### **REMARKS**

The Office Action dated March 11, 2005 has been received and carefully reviewed. The preceding amendments and the following remarks form a full and complete response thereto. Claims 1-3 and 7-8 are amended. Claim 4 was cancelled without prejudice or disclaimer. Claims 11-14 have been added. No new matter has been added. Support for the new claims can be found, *inter alia*, in Fig. 2 and at pages 5-6 of the specification, and in the original claims. Accordingly, claims 1-3 and 5-14 are pending in the application and submitted for reconsideration.

The Applicant submits that the exact view of the anchor patented by FR 2820108 is:

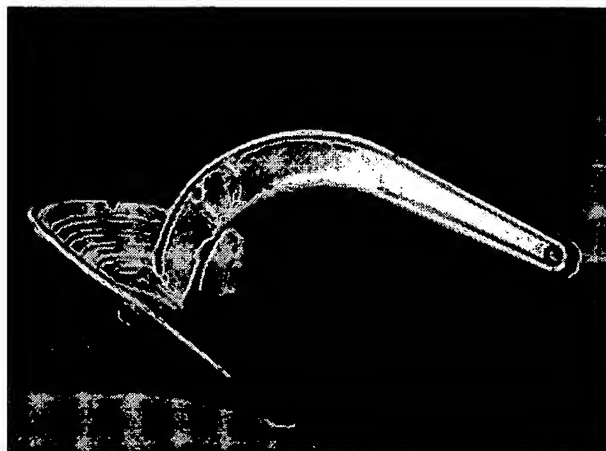
Regarding the position of the shank, in FR 2820108, the position of the fixation of the shank has not been conceived to increase the weight repartition on the anchor tip. FR 2820108 fails to disclose or suggest that "the shank is mounted on the half portion of the fluke." The drawing in FR 2820108 is merely an "artistic" representation of its anchor. On its Fig. 2 , the angle B described as the angle formed by a straight line joining end(3) to end (15) connected to fluke (2) and a tangent to the center line (9) of fluke (2) is between 34 and 40°. Applicants measured this angle B on the FIG 2 to be 42 °. Thus, the drawings are unreliable and should not be interpreted to show the claimed feature.

Clearly, the shank is mounted on the back half of the fluke.
